## Town of Mammoth Lakes

### Planning & Economic Development Commission Staff Report

**Meeting Date: May 11, 2022**

**AGENDA TITLE:** Consideration of Tentative Tract Map (TTM) 22-002, Use Permit (UPA) 22-001, and Major Design Review (DR) 22-001, for approval of the “Limelight Hotel” development project located at the northwest corner of Canyon Boulevard and Lake Mary Road (Mammoth Hillside site) in the “Plaza Resort” and “Specialty Lodging” zone of the North Village Specific Plan Area. Pursuant to the California Environmental Quality Act (CEQA) Guidelines, an Addendum to the 1999 Subsequent Program Environmental Impact Report (SPEIR) was prepared for the Limelight Hotel project.

## PHYSICAL COLOR AND MATERIAL BOARD

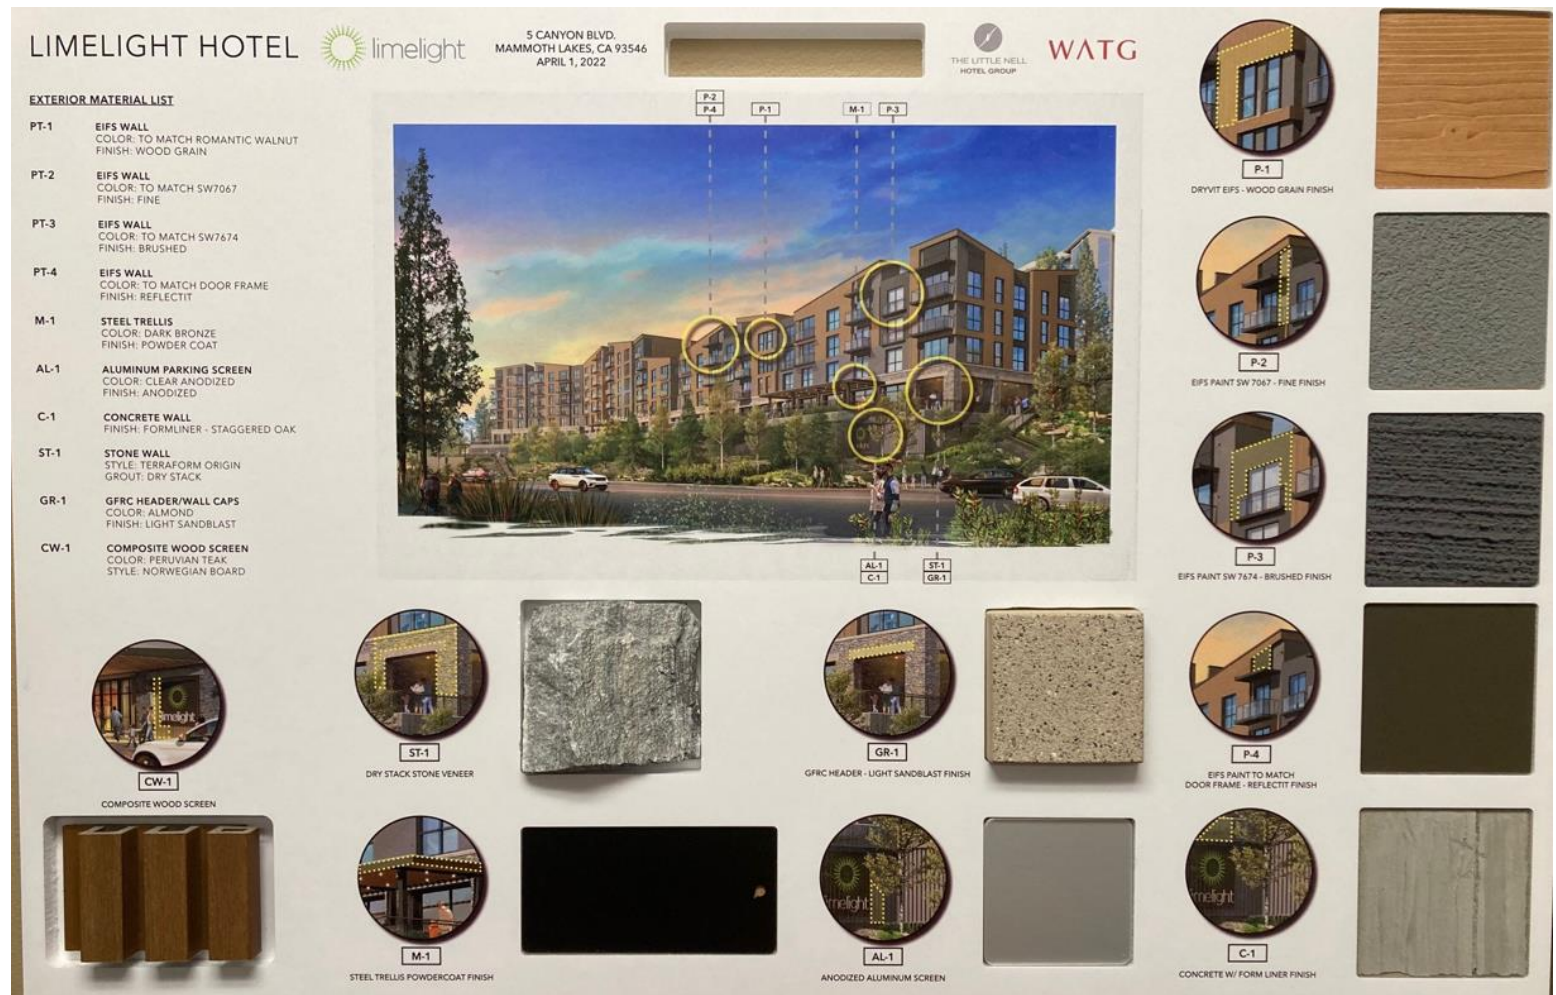
The exterior colors and materials were submitted in a digital format for review by the Advisory Design Panel. Digital renderings along with the proposed colors and materials we provided with pictures, rather than physical samples due in part, because public meetings were being held virtually. Once physical color and material samples were received by Town staff on April 11<sup>th</sup> (shown below), staff determined that two of the proposed materials/colors do not provide the same appearance of the color or material that was reviewed digitally. These colors and materials should be modified to meet the intent of the North Village Design Guidelines and ADP

recommendations. Staff suggests that the following conditions of approval be included for the project to ensure the design is consistent with the NVSP Design Standards and ADP recommendations:

- The color and finish for the “Anodized Aluminum Screen” surrounding visible portions of the parking garage should be changed to a darker color such as dark bronze and shall have a non-reflective finish.
- The color of the proposed “DRYVIT EIFS – Wood Grain Finish” siding material shall be changed to another wood grain finish that is darker and has less orange/peach tone.
- The applicant should provide a 3’ by 3’ foot mock-up of the proposed stone material and installation.
- The applicant should provide a more detailed elevation for the design of the retaining wall located at the corner of Canyon Boulevard and Lake Mary Road to ensure the design adequately diminishes the overall height of the wall.
- The applicant should provide the proposed gate or roll-up door design for the service entrance portal off Canyon Boulevard.
